TEXAS INSTRUMENTS			
TITLE			
THUB2077 REV A			
SIZE		DRAWING NO.	REV
D		9833202-9901	A
SCALE: NONE		SHEET 2

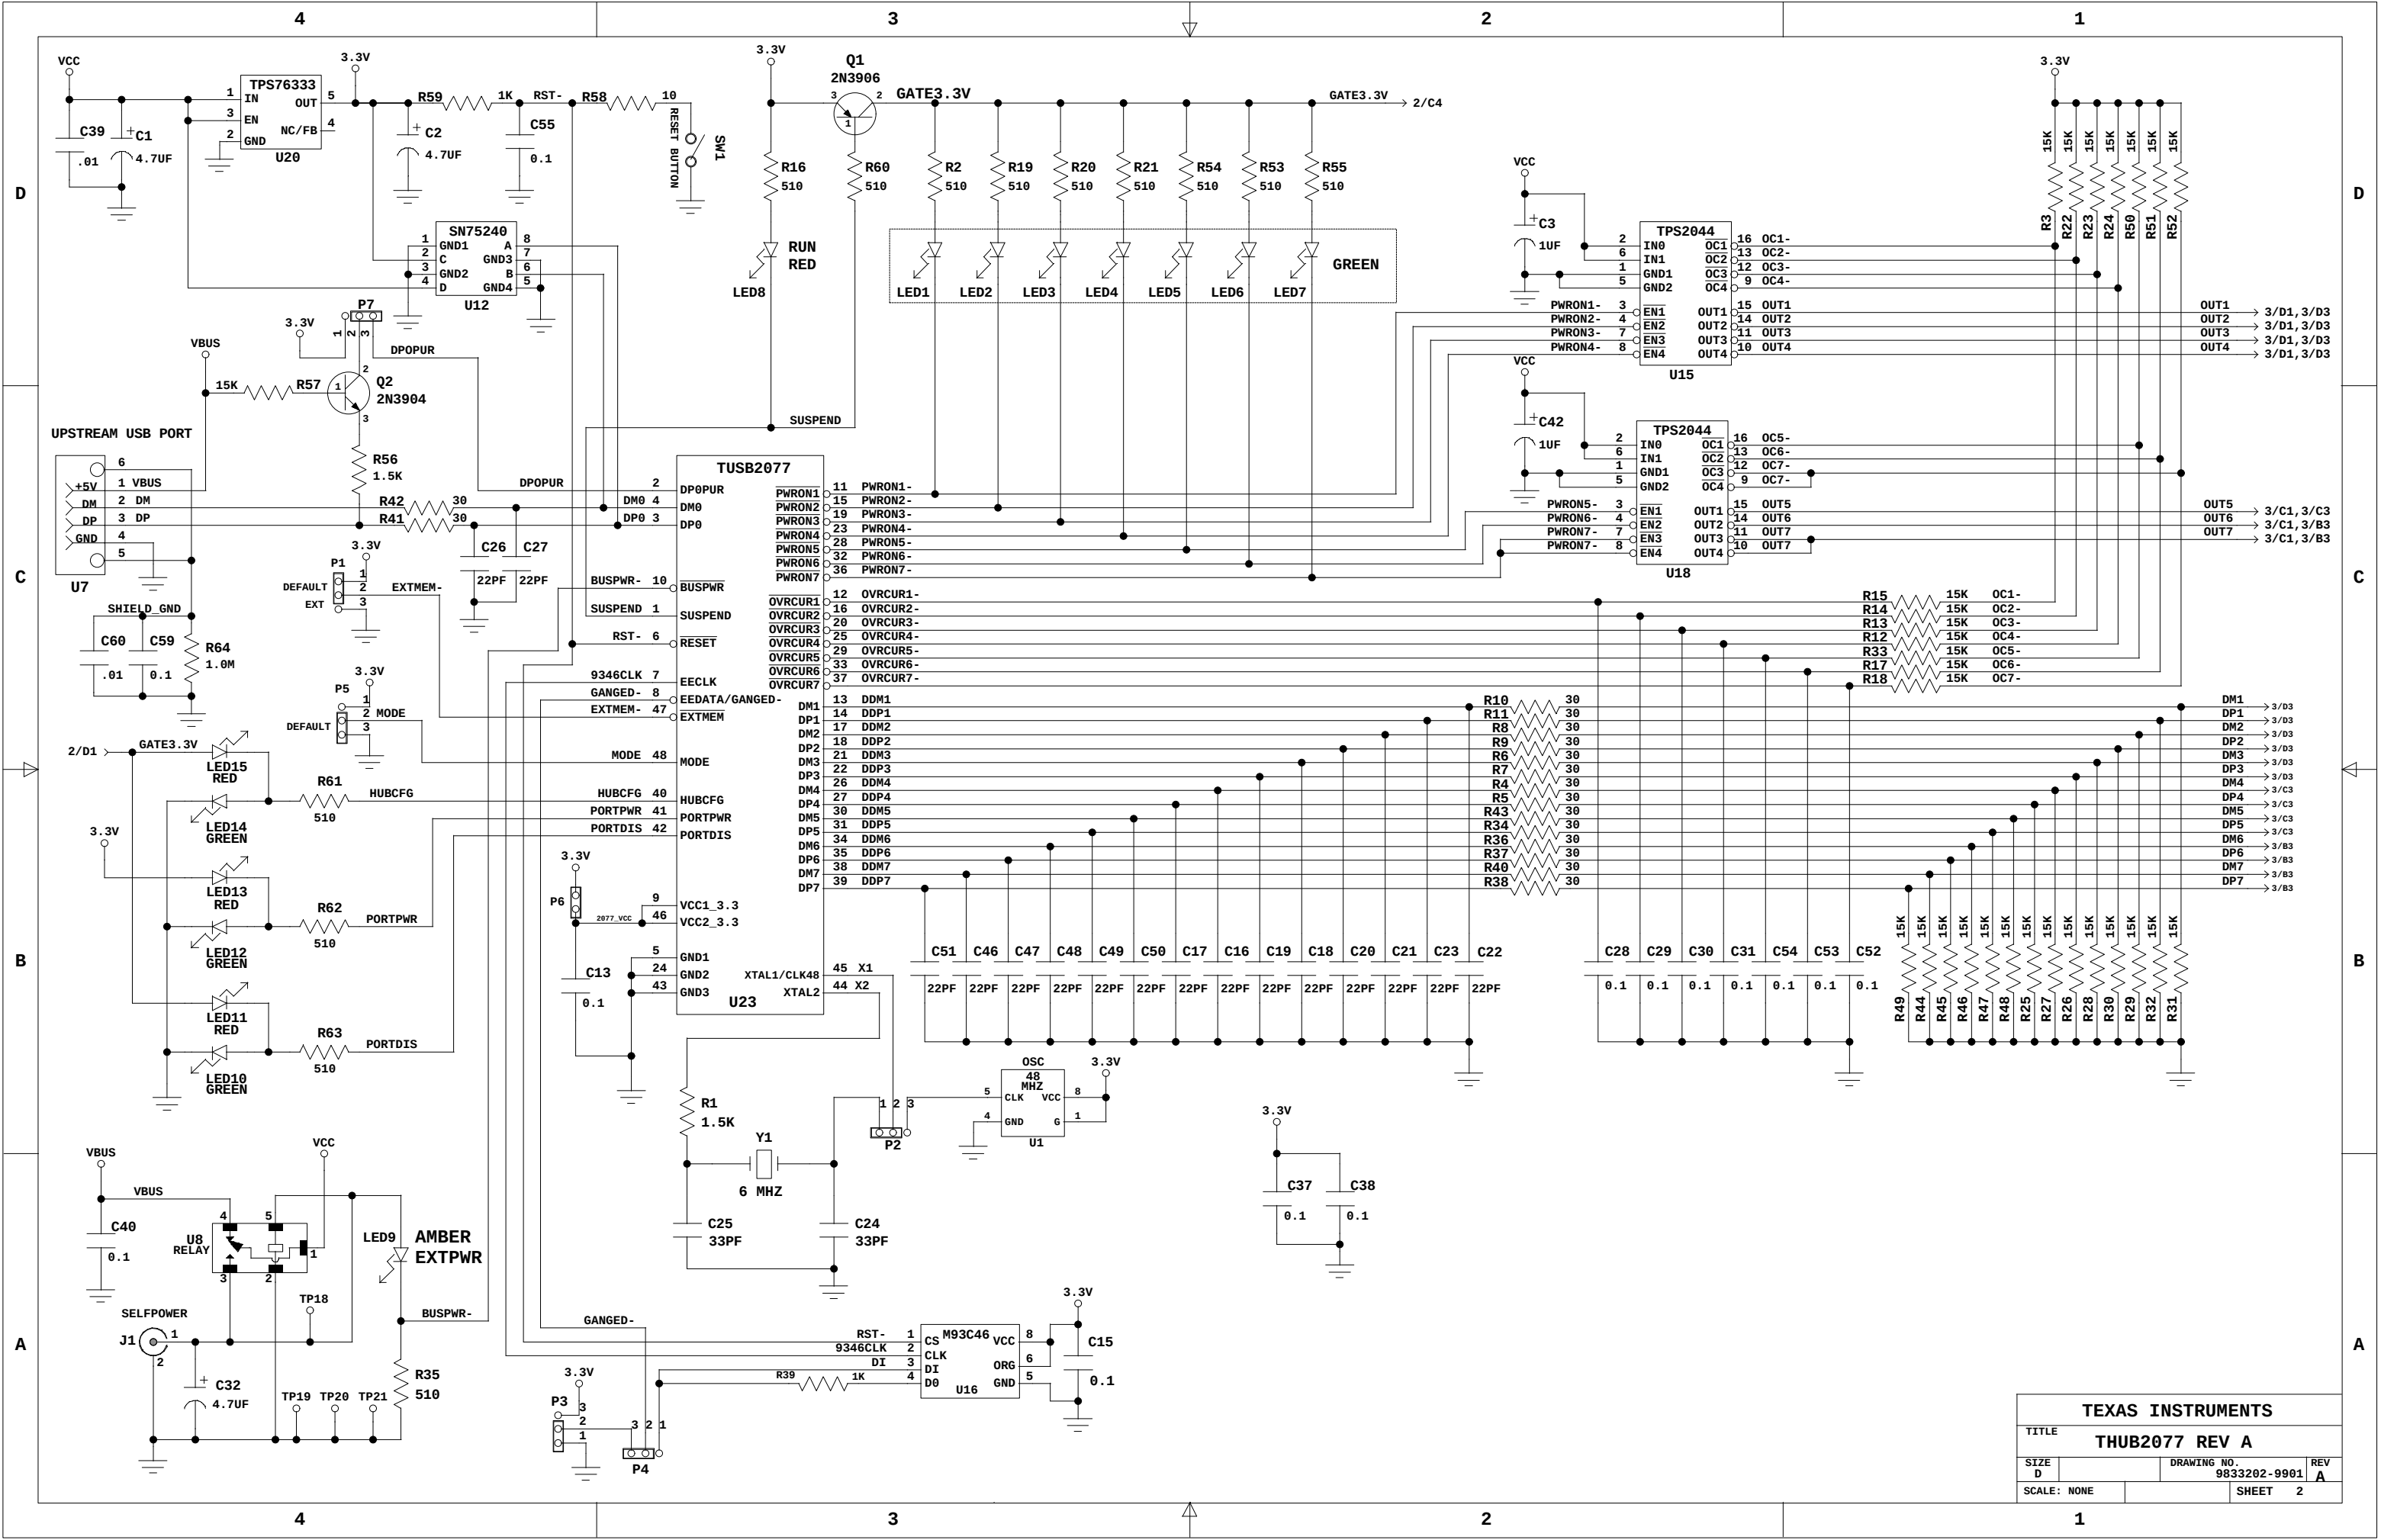
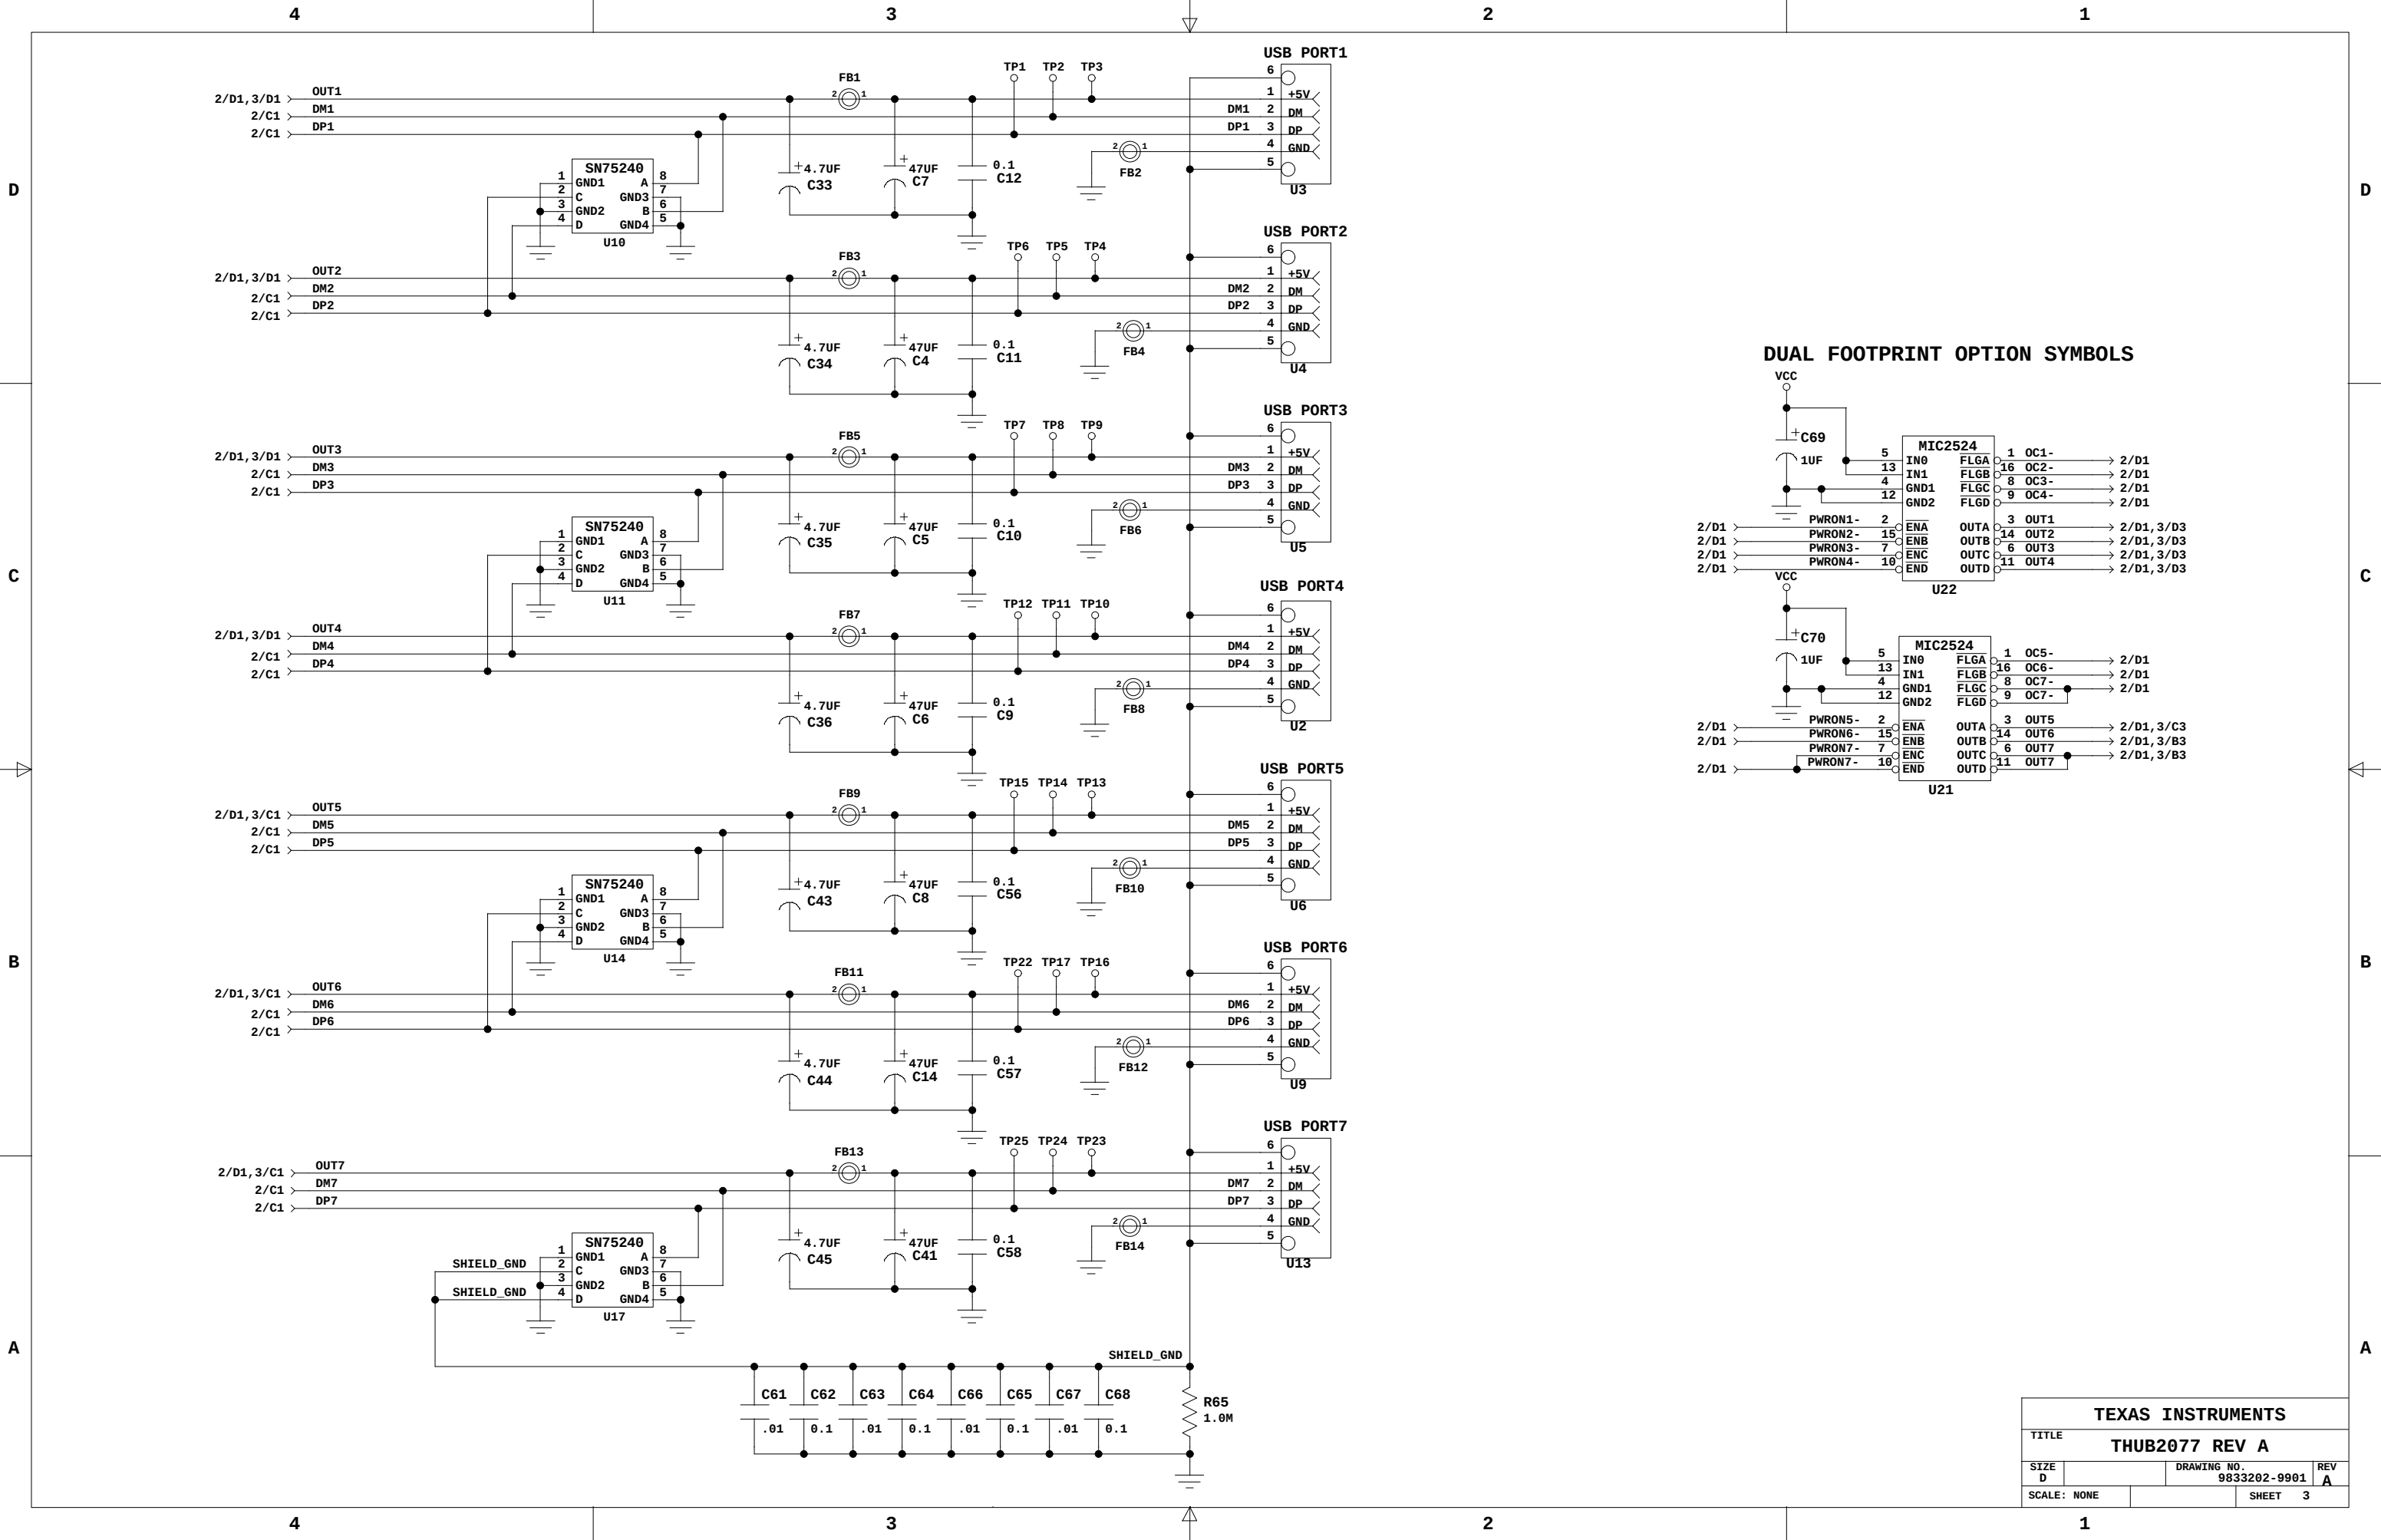
REVISIONS			
REV	ECN NO / CLASS / DRAFTER / DATE	DATE	APPROVED
A	Remove FB15, add 3 pin jumper to pin 2 of Q2	Nov. 16, 99	
	Change power source on LED10 & 15		
	Remove socket U19
